**Re: Shoreline Substantial Development Permit 2016-00415
East Lake Sammamish Trail, South Sammamish B Segment**

PLAN AND PROFILE

EAST LAKE SAMMAMISH
SOUTH SAMMAMISH SEGMENT B
SAMMAMISH, WA

DATE: 4-20-15
AL10

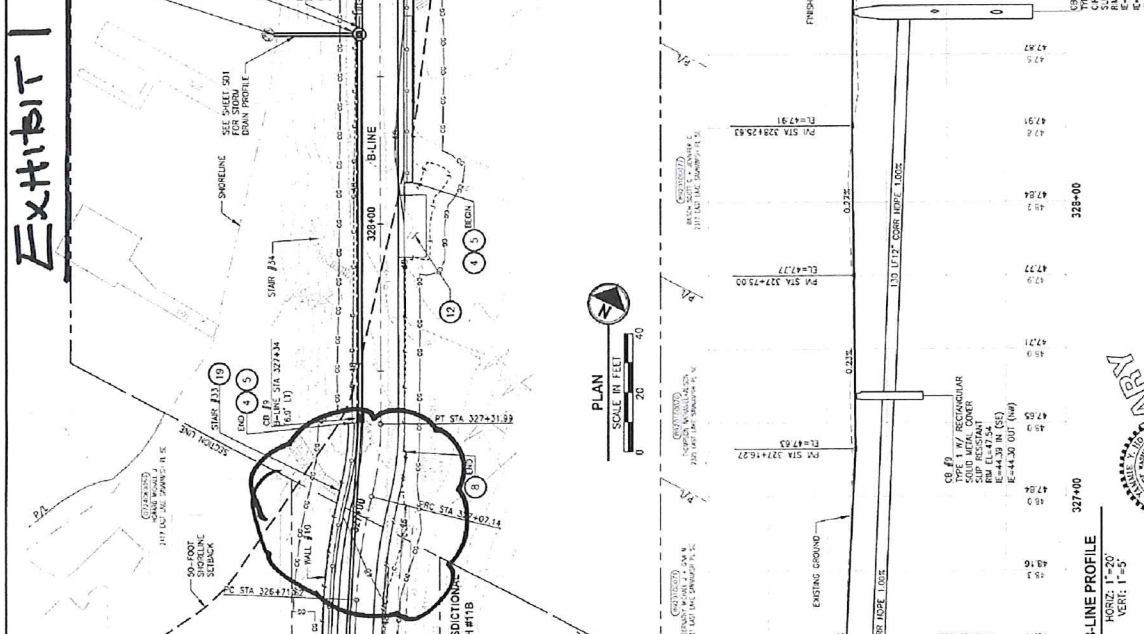
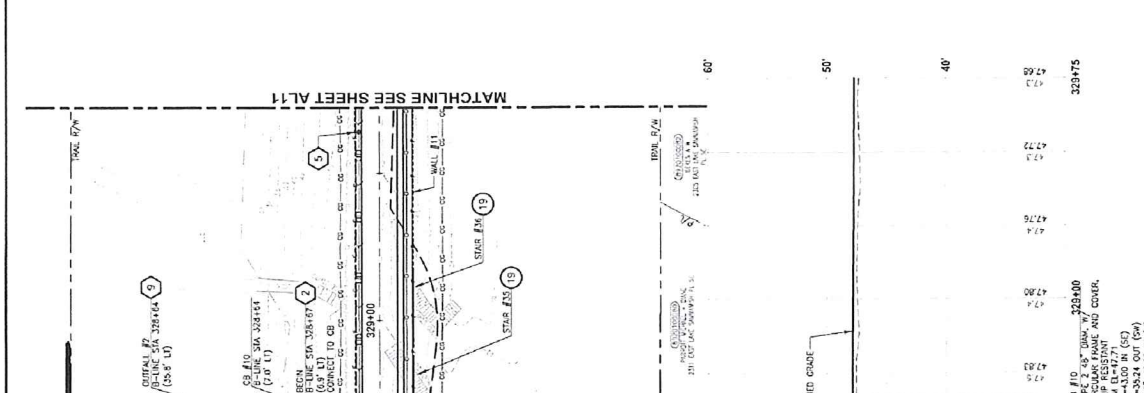
Now I would like to draw your attention to Exhibit 7, the current 60% Plan, Plan and Profile AL10, Bates #000096.

Notice the area indicated to be Wetland 15D. Further notice the line shown as ->----UD->-----UD located in the heart of Wetland 15D.

A line of this nature implies an Under-Ground Drain. The plan as its presented indicates the intent to replace the existing Wetland 15D with an underground drain.

Common sense tells me that installing an underground drain is not the same as avoiding the wetland. Claiming the wetland 15D is being avoided is an outright falsification and but one indication of how the evidence provided by King County should be discounted.

Specifically, the proposed realignment occurs between stations 327+31.99 and 326+71.62.⁴ The realignment results in the following significant, adverse impacts, among others:

- **Reduced Utility of Shared and Separate Driveways** – The realignment shortens the approach to the shared portion of my clients' driveway and severely limits vehicle maneuverability and ingress and egress from the easternmost portions of their separate driveways. In particular, the turning radius of their driveways are significantly compromised and may require the owners to trespass onto each other's property for future, rudimentary driveway navigation.

- **Reduced Safety/Visibility** – The proposed Trail realignment creates an increased safety hazard for both vehicles and Trail users at this crossing. Specifically, the rather abrupt realignment near the north property line of the Greve Property appears to reduce sight distance for vehicles exiting the shared portion of my clients' driveway, which decreases safety for both my clients and Trail users.

My clients propose that the abrupt transition for the Trail centerline realignment currently depicted as occurring between stations 327+31.99 and 326+71.62 be shifted to the south between stations 324+50 and 324+00.⁷ It does not appear that shifting the transition to that location would impact any adjacent properties, as that location does not involve constraints that are similar to those in the immediate vicinity of my clients' property. For example, unlike the County's proposed location, my clients' proposed location is not in the vicinity of a Trail crossing, such as a driveway. Moreover, my client's proposed location for the transition would alleviate concerns regarding impaired sight lines at my clients' Trail crossing, as the Trail alignment could be straightened in the absence of the proposed transition. My clients' proposal would also accommodate the following:

- **Retaining Wall #10** – My clients' preferred alignment would allow for Retaining Wall #10 to be moved east, closer to the alignment of the Trail, which could then be reengineered to be either a smaller retaining wall, or be eliminated altogether as a result of existing elevations. This common sense change would result in considerable savings to taxpayers.⁸

(1) Continue the underdrain depicted for installation south of station 326+00 on the east side of the Trail through to station 327+31.99. Tie the underdrain to Catch Basin #9 located at station 327+34.

SHEET NO. 14 OF 15
EX 6

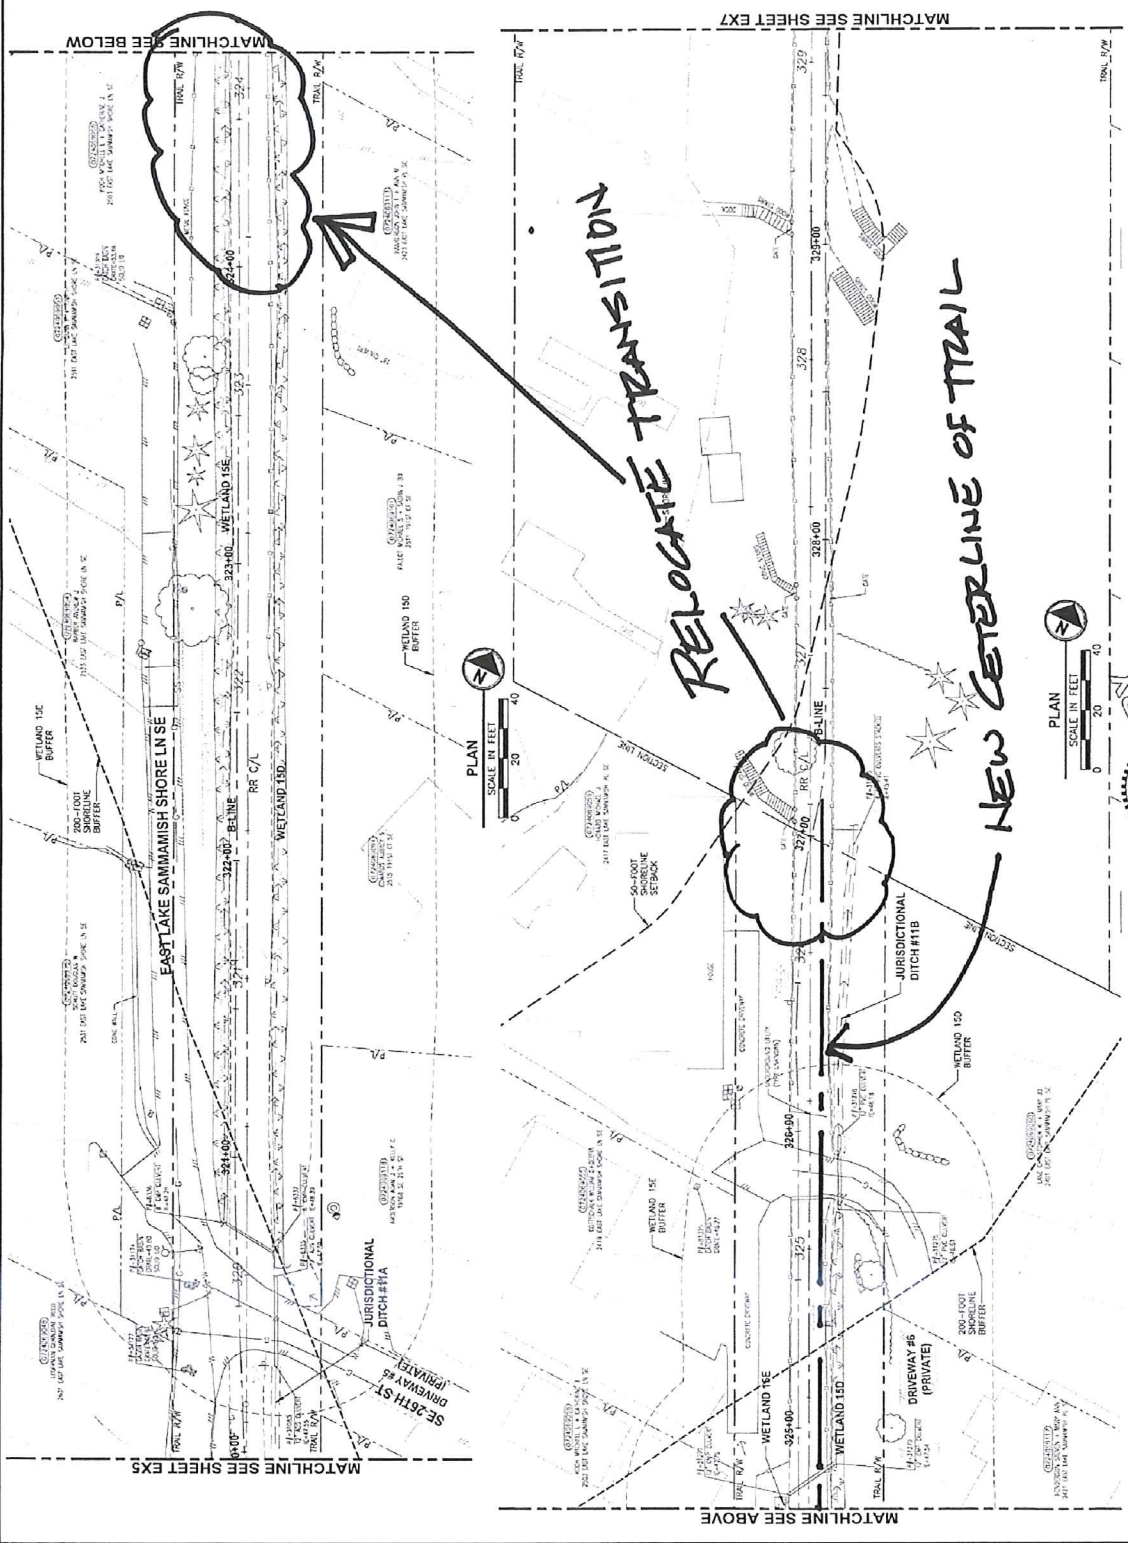
Per the Preliminary Plans, it appears that the County is unnecessarily realigning the centerline of the Trail waterward (*i.e.*, closer to my clients' residences).² Notably, the County has previously published the criteria that it employs to determine if the existing centerline of the Trail should be realigned, which include the following: (1) "[m]inimizing costs where possible without impacting trail standards," and (2) "[m]inimizing impacts to adjacent homeowners."³ As explained in greater detail below, it does not appear that the County's proposed realignment complies with either of these criteria.

Exhibit 6

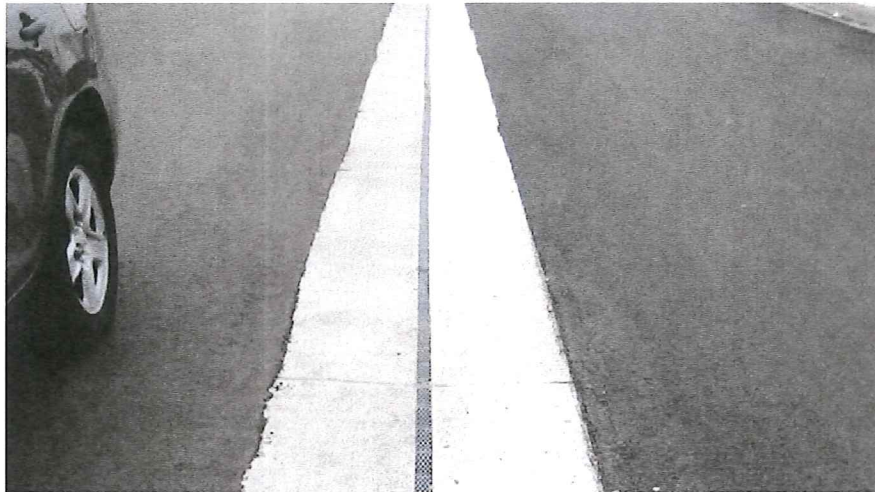
(2) To address the additional ponding that will be expected from increasing the impervious surface from the Trail due to widening, my clients request the installation of a CMP slotted trench drain in the existing driveway, such as the product available from Contech Engineering Solutions depicted in Exhibit 6.
